This letter is in response to the on site meeting that we, (You, Chris Conrad of the BLM and myself) held at the Carnotite West Uranium mine in Emery County. After the meeting, I expected to hear from UDOGM requesting any further information required to complete the Revised Notice of Intent that I filed in April of last year. As I have not heard from UDOGM concerning that meeting, I will present here changes to the Revised NOI that should meet with UDOGM concerns. I believe that this information should enable UDOGM to approve of the Revised NOI submitted. My understanding of that meeting is that four items were discussed and tentatively agreed upon.

# Carnotite West Mine

#### Revised Mine Site Diagram;

**Diagram Showing Dimension and Elevations of the Proposed Mine Site;**

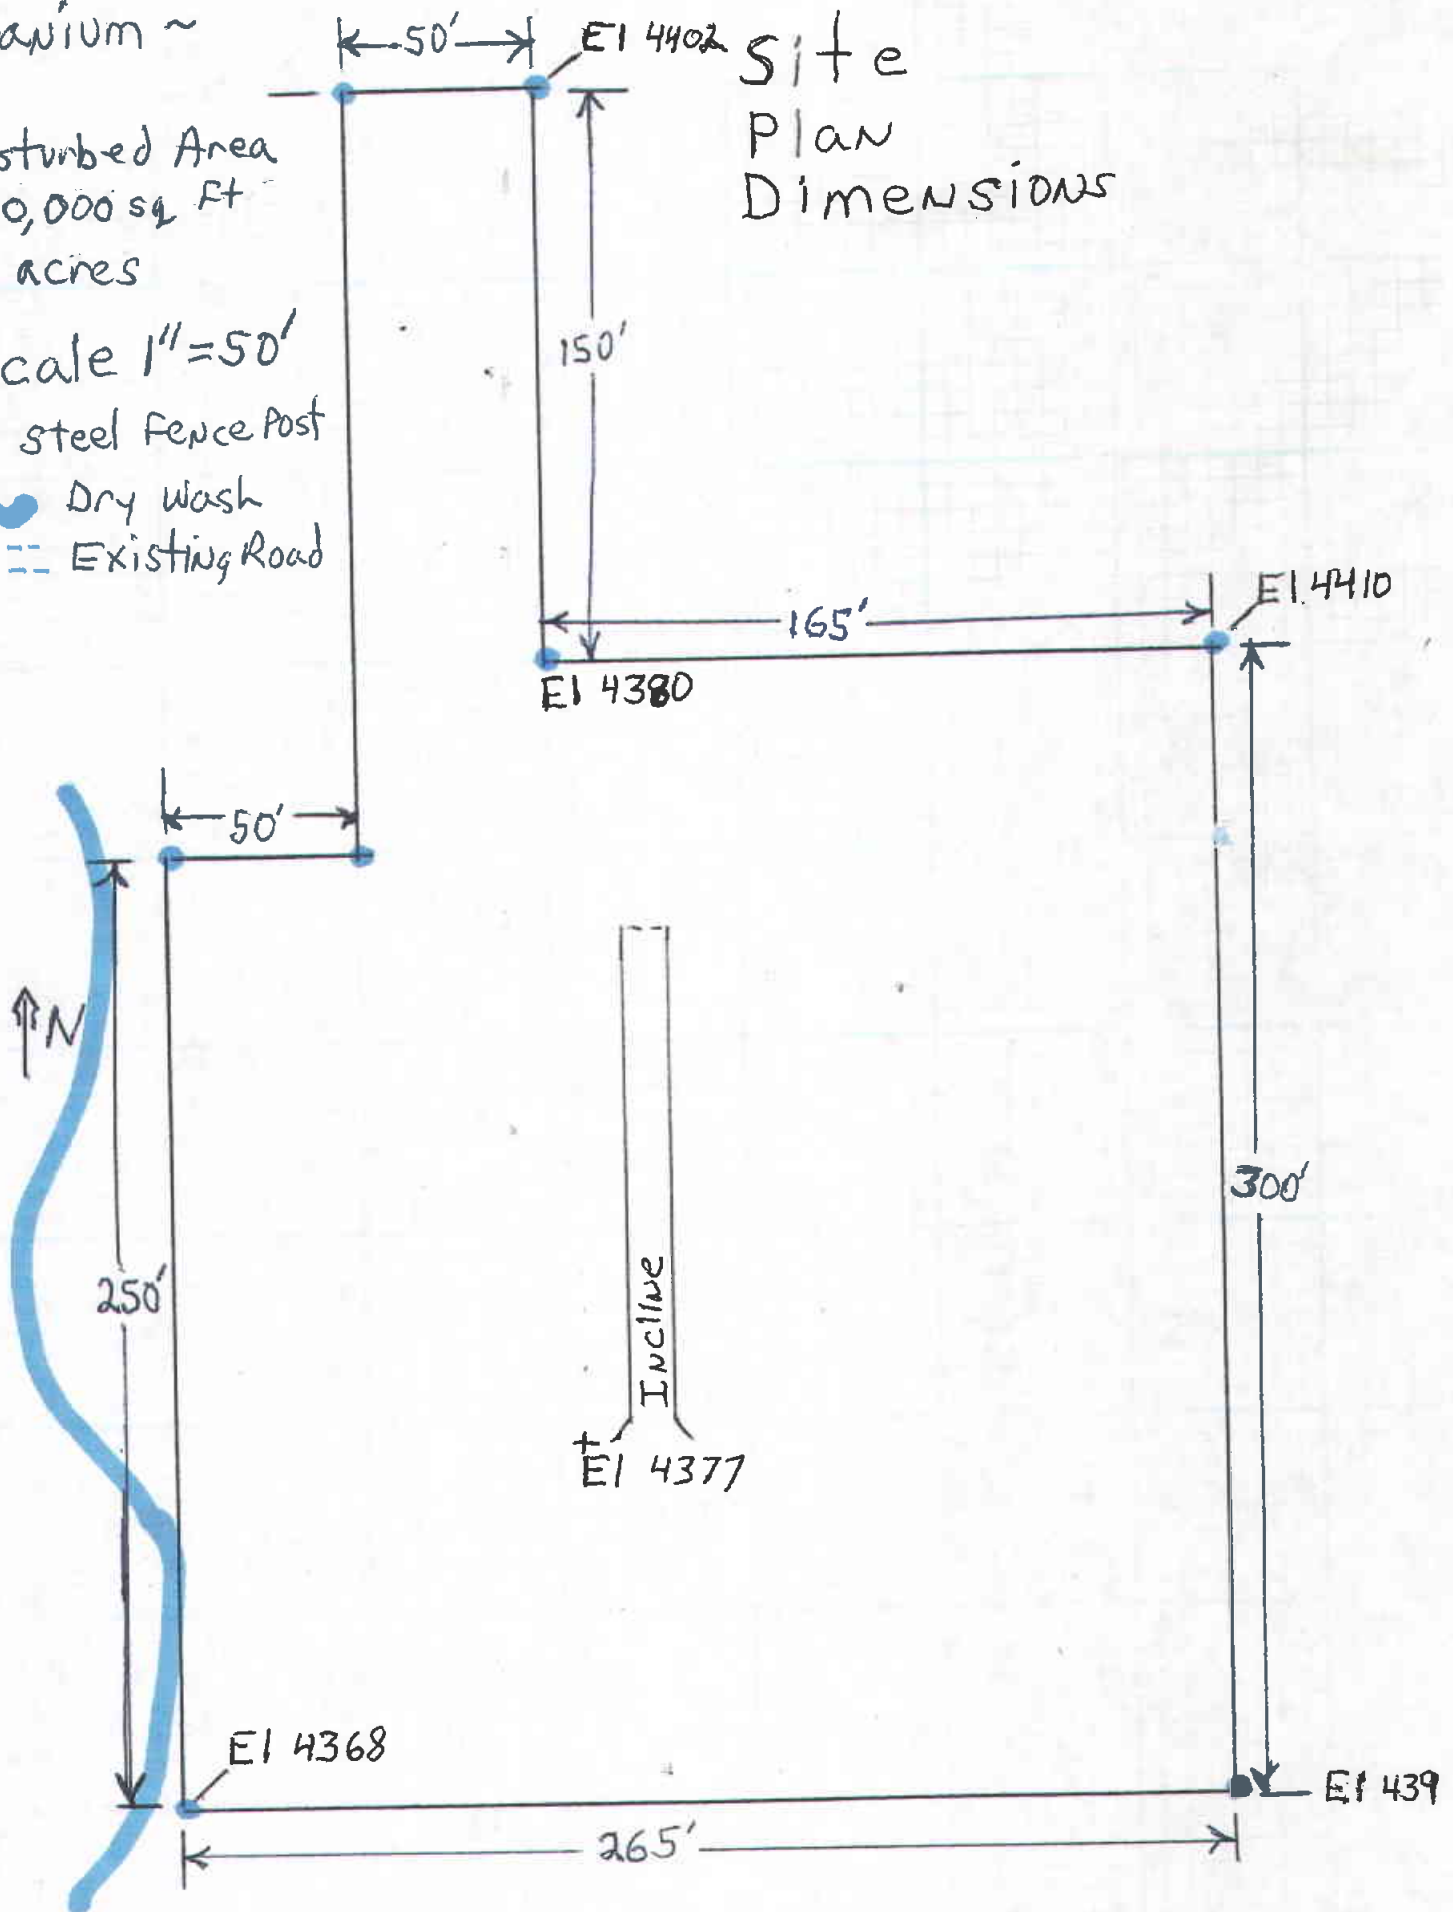
2. That UDOGM wants the Carnotite West mine to change the revised NOI to avoid using the existing mine dump marked #4 on the diagram of the proposed disturbed area. The purpose of this is to leave the small dry wash drainage on the West side of the mine site in an undisturbed condition. In our revised NOI that is where the majority of mine waste rock was to be permanently deposited. However we agree that it would be best to change our plans and leave the small wash as it is. This will require eliminating an area 135 feet X 250 feet from the West side of the proposed disturbed area. It will also leave the existing #4 waste dump in its present unreclaimed condition after the reclamation of the mine site is completed. In order to make this change viable to our mining operation we will also change the boundary of the proposed disturbed area to include adding an area 50 feet X 165 feet to the North East portion of the site. That addition will be used as an enlarged area to permanently place the waste rock that we had intended to place on the existing #3 and #4 waste dumps. Adding this area to the NE will also enclose some additional existing waste rock dumps within the proposed mine site. All of the existing waste rock dumps and all of the surface disturbances related to past mining activity will then be within the proposed mine site and would eventually be reclaimed. The exception will be that the existing #4 waste rock dump must be left as it is so as not to disturb the dry wash area. These changes to the revised NOI will reduce the total area proposed from 2 1/2 acres to a total of 2 acres and have been marked on the ground with green steel fence post as required by UDOGM. New mine site diagrams reflecting the changes are included.

This diagram is of the mine site after changes requested at the on site meeting. The changes to the proposed mine site will leave the small dry wash environment on the west side of the mining claims undisturbed by our mining activities. There are also some corner elevations shown on the diagram. The changes to the proposed mine site are 1. An area of 135' X 250' on the West side of the mine site was eliminated to protect the small dry wash area. 2. An area 50' X 175' was added to the North East side of the mine site. These two changes leave a disturbed area of 2 acres. The elimination of 135' on the west was requested by UDOGM at the on site meeting. The addition of 50' on the NE will bring some existing waste dump material into the mine site. With these changes all of the existing waste rock dumps and surface disturbances from past mining operations will be within the proposed mine site and will be reclaimed at the end of mining.

#### Radiation Survey Diagram;

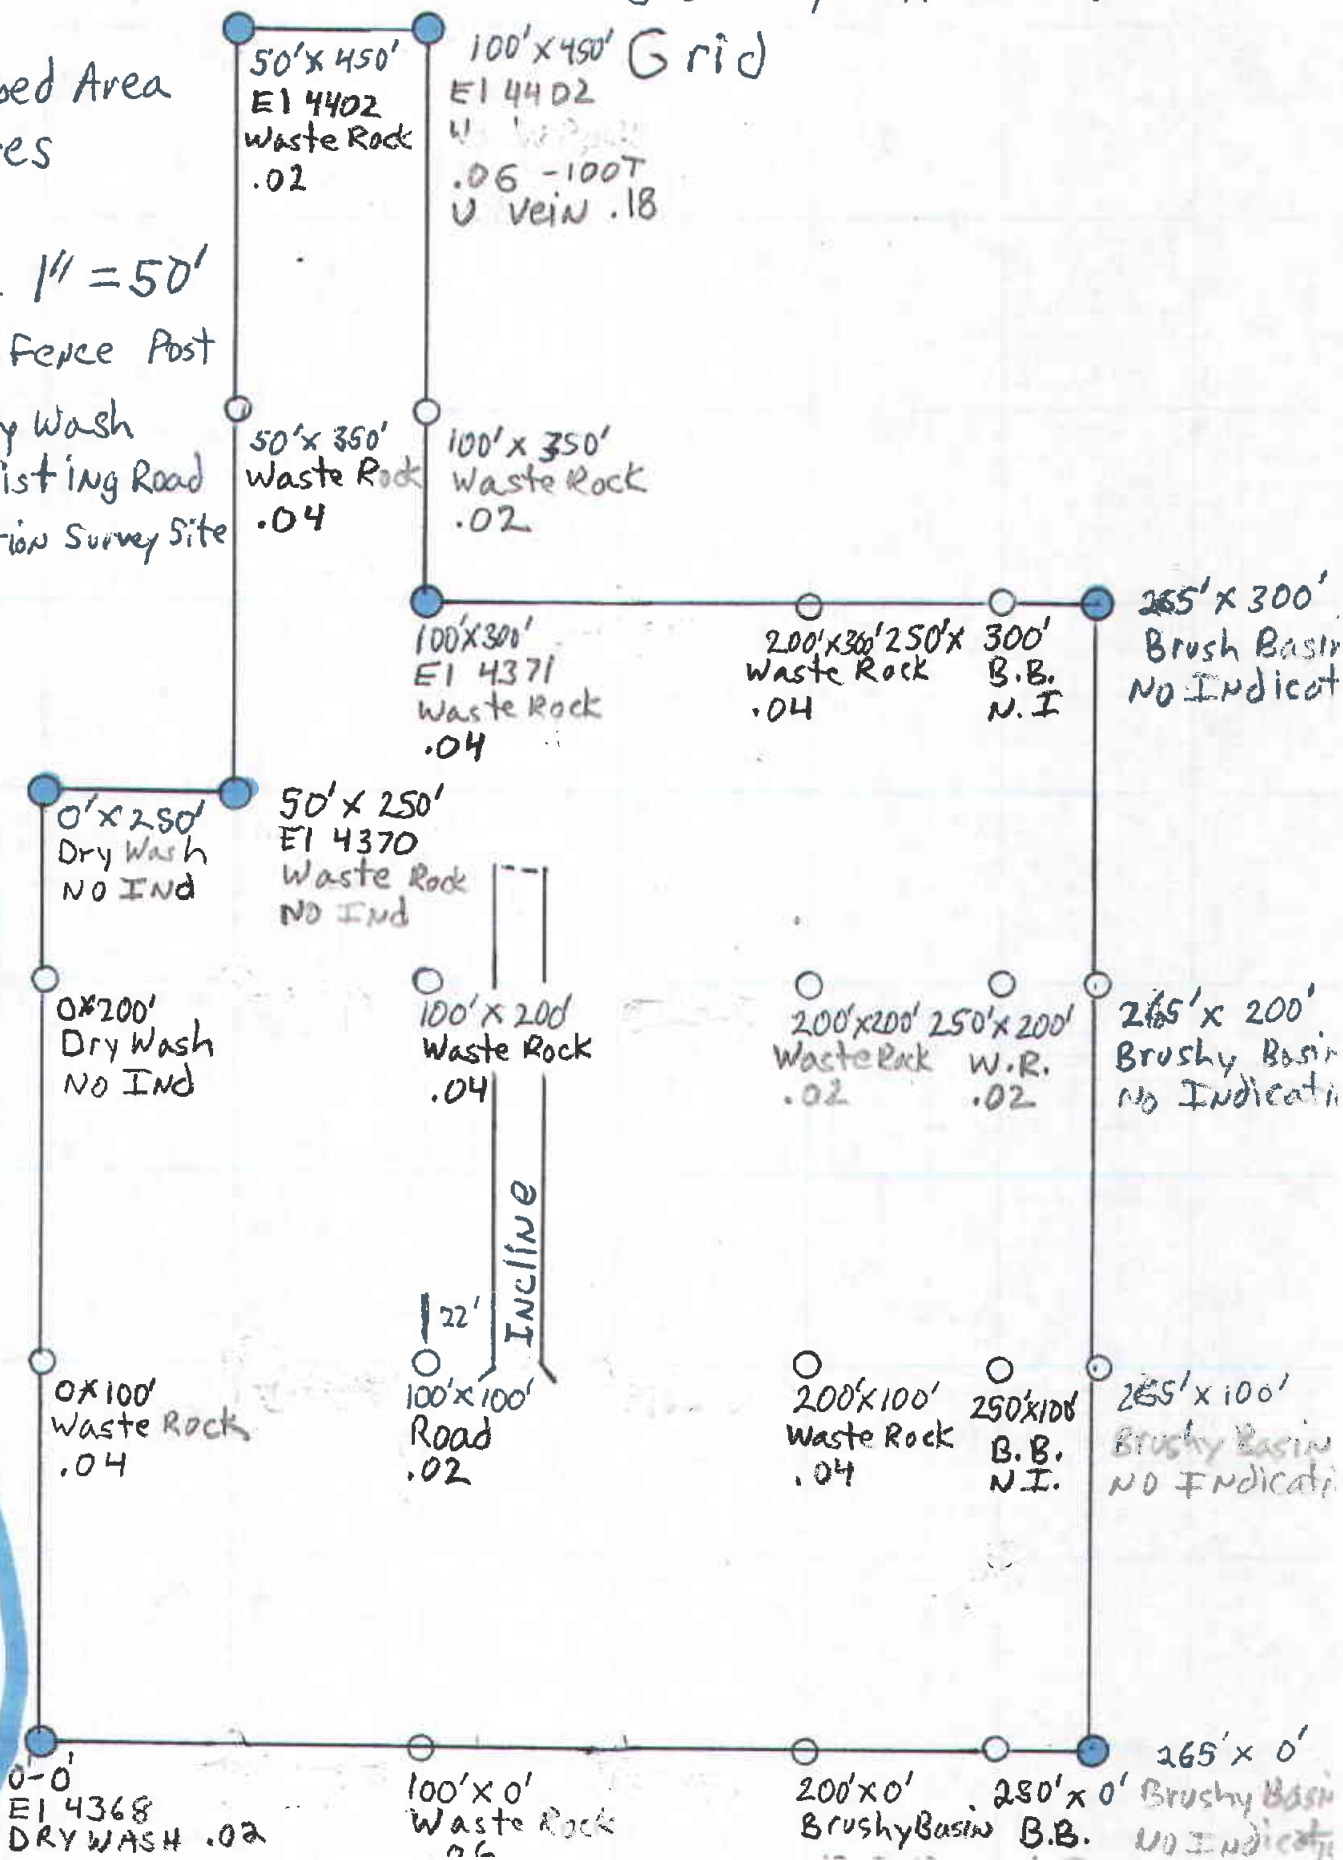
4. You recommended that I perform a radiation survey of the proposed disturbed area. I have found no reference to a radiation survey in the NOI information package and there are also no criteria for such surveys in the information sent to me by UDOGM. At your recommendation I set up a 100' X 100' grid on the mine site and made a radiation survey using my industrial geiger counter. Most of the existing mine waste dumps were found to have radiation levels of 0.04% Uranium or less. There are two exceptions. This Radiation Survey as completed will fulfill all of my needs in this area and lacking any UDOGM guidelines, should also satisfy your need to understand the elevated radiation levels in the proposed disturbed area. If UDOGM wishes to conduct their own survey the grid is still in place. As was found when you were taking radiation readings on site, the entire area has higher than background radiation levels. Some areas of the existing waste rock dumps also have slightly elevated radiation levels. None of this should be unexpected, the mine site is on the Colorado Plateau which has the highest background radiation to be found on the continent. Buckhorn Draw has a large underground uranium deposit and there are exposed surface Uranium veins within the proposed mine site. In our mining plan we proposed that most of the low grade and waste rock produced during mining operations would be backfilled into open areas and existing stopes underground. Only 10,000 tons of waste rock with less than 0.04% Uranium will be brought to the surface and permanently deposited. At the end of reclamation of the mine site, the revegetated mine waste rock dumps should have less than 0.04% radiation which is probably less than many other Uranium mining areas in the state of Utah.

This diagram shows the results of a radiation survey of the proposed mine site done in October of 2008. A simple 100' X 100' grid was established on the mine site and an industrial Geiger counter with a percentage scale was used to monitor radiation levels at each point on the grid. No indications of radiation was found in any areas of the dry wash. All of the grid point on the East side of the mine site are on the Brushy Basin formation and none of them showed any indication of radiation. There is an area in the NW of the mine site where there is approximately 60 tons of low grade ore that has a 0.10% radiation level. This is in association with an exposed 0.25% Uranium vein. Once mining begins we will transport this low grade ore underground for disposal in the back fill areas. There is not much we could do about the exposed Uranium vein except to bury it with waste rock during reclamation. The second existing low grade ore area has 50 tons of slightly higher radiation (0.10%). This area straddles the South boundary of both the proposed mine site and our 8 Ball #3 mining claim. The removal of all the low grade poses possible conflicts with the claim owners to the South of our mining claims as half of it is on their mining claims. This low grade ore will also be brought underground for permanent disposal. The other grid points were in existing waste rock areas and most showed levels of 0.02% and 0.04% . At the time of reclamation only waste rock with less than 0.04% will remain on the surface. Any material found with a higher count will be back filled underground.
